# Determination 2025/037

## Refusal to issue a code compliance certificate and compliance of a pool, deck and pool barrier

**124 Tiffin Hill Road, RD2, Parkvale, Carterton**

**Figure 2: Plan view of the pool (not to scale)<sup>7</sup>**

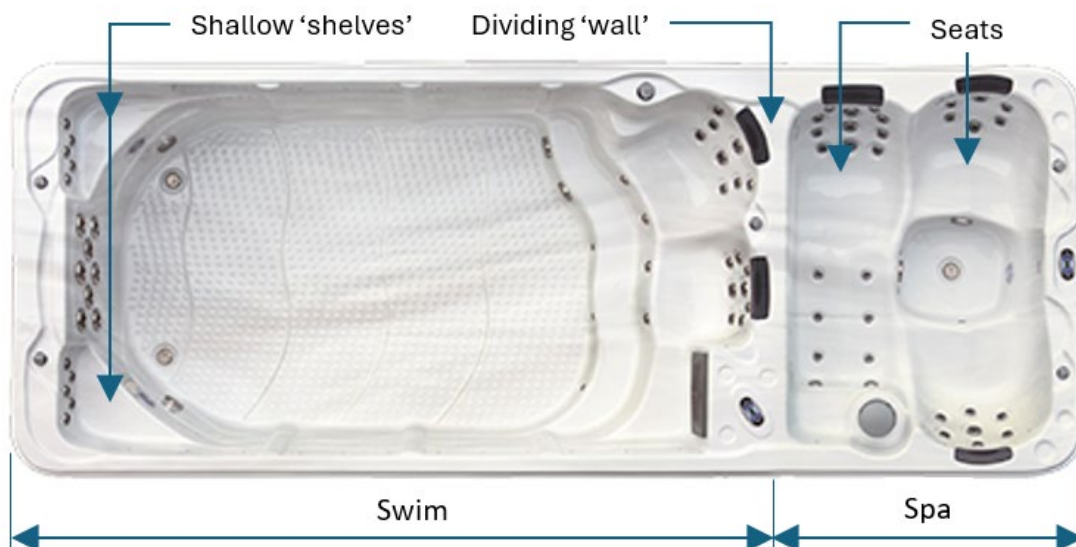
5.12.2. the pool edge has variable flat or slightly undulating surfaces and these, in addition to the dividing wall (see figures 2 and 4), are in my opinion wide enough in some places for a person to perch, sit, or stand

**Figure 3: View looking south**

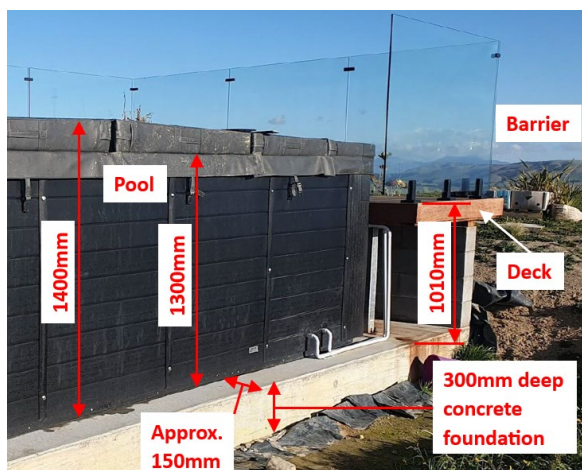
- 2.4. Towards the southwest end of the pool are two small diameter pipes (see figure 3) that pass through the external shell at approximately 150mm high at about 600mm or less from the end of the pool.<sup>6</sup> Vertical sections of the pipes are located under the deck.

5.22. There are also two permanent pipes near the southwest corner that intersect the pool wall. The pipes are approximately 150mm in height above the top surface of the concrete foundation (refer to figure 3) and appear to be sufficiently close to the edge of the deck that they could provide a step up or toehold for a young child.

5.23. The pipes are small in diameter, and I have insufficient information to determine whether they would, either individually or together, be of sufficient rigidity and strength that they would assist a young child in negotiating the barrier. For that reason, I make no finding on the compliance of the pool barrier with clause F9.3.3 with regard to the pipes.

**Figure 4: View of southwest corner**

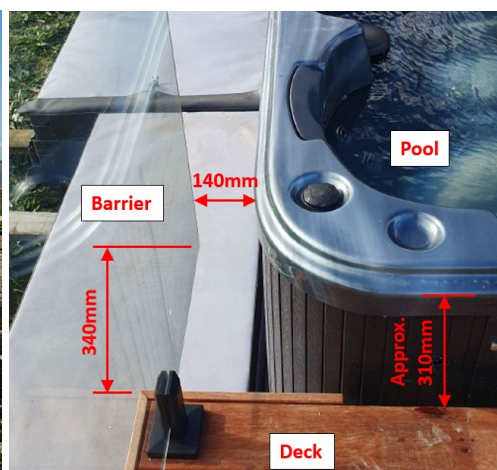
- 2.5. The 1010mm high deck wraps around three sides of the pool, leaving the northwest side of the pool open along the approximate 5.2m length. The glass barrier fixed to the deck encloses an area around the pool on three sides and overhangs the deck approximately 340mm at the southwest corner of the pool and 280mm at the northeast, with a gap of 140mm between the barrier and the pool (see figure 4).

5.14. Further, the deck is also more than 1m in height and there are 140mm wide gaps between the glass barrier and the pool at either end. While a person may not fall through the 140mm wide gap, it is wide enough to allow a person’s foot or lower limb to pass through and is at the end of the barrier where a fall may not be arrested.

5.20. The glass barrier and the pool wall form the physical barrier to the pool. These two elements surround the majority of the pool, with the exception being at either end of the pool where there is a small section between the pool and the glass barrier. At these two points there is a discontinuation of the physical barrier to the pool, and I consider this does not comply with clause F9.3.2(a).

5.21. In addition, I am of the view that, in light of the combined as-built vertical and horizontal distances involved at either end of the pool, the deck being approximately 1010mm high and accessible from the northwest side of the pool would assist a child under 5 years of age to negotiate the pool barrier formed by the pool wall. In this regard I consider the pool barrier does not comply with clause F9.3.1 or F9.3.3.
